Subject: RE: P/23/20/DOC AND SUMMER LANE PUBLIC OPEN SPACE

P/23/20/DOC AND THE SUMMER LANE PUBLIC OPEN SPACE

Photo 6 Taken 9/2/23 taken from telegraph pole seen in Photo 5 showing incline in land towards houses on Pagham Road with mound in background.

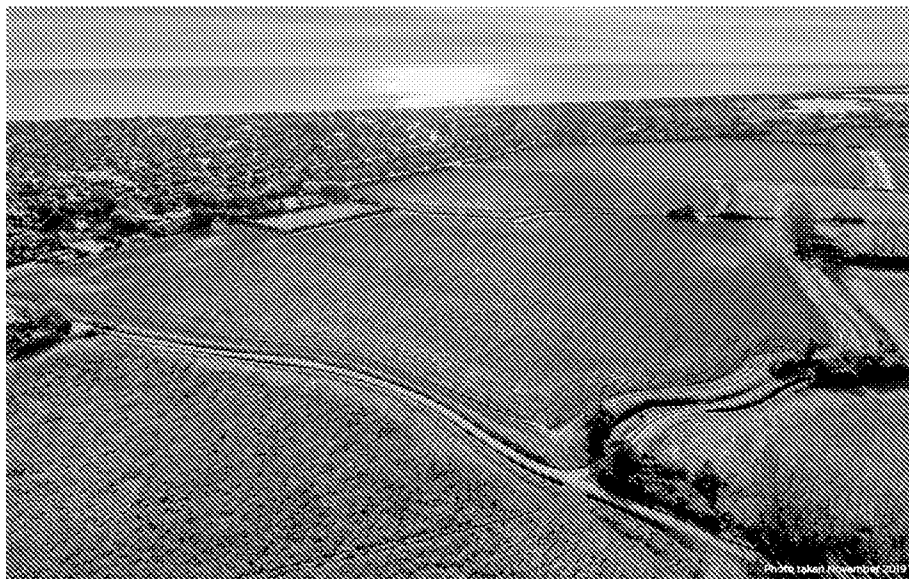
5. The result of this deposition is that the whole area of the POS is approximately 1 metre higher than the original level land. Houses on the eastern edge of the POS have gardens which were originally above the level of the field. Residents are quite clear that prior to this activity, water accumulation on the field used to run off to the west. They are now well below the level of the field and in recent months some of those house's gardens have been flooded so badly that the water has flowed through their gardens into Pagham Road from curb to curb. Two houses have had to resort to pumping water off site onto Pagham Road. If photo Savill 002 is blown up, it indicates that the buildings to the east and the Pagham playfield are higher than the field. If you stand at the north-west corner of the Pagham village hall open space the higher level of land is very clearly seen. As stated, we are presently investigating the land raising. We are also aware of the flooding issues. Can you advise how you have arrived at the suggestion that the land has been raised by 1m? There are no known records of the previous levels of the original field that we are aware of so whilst all the evidence points to the fact that levels have been raised, it is difficult to say with any certainty by how much.
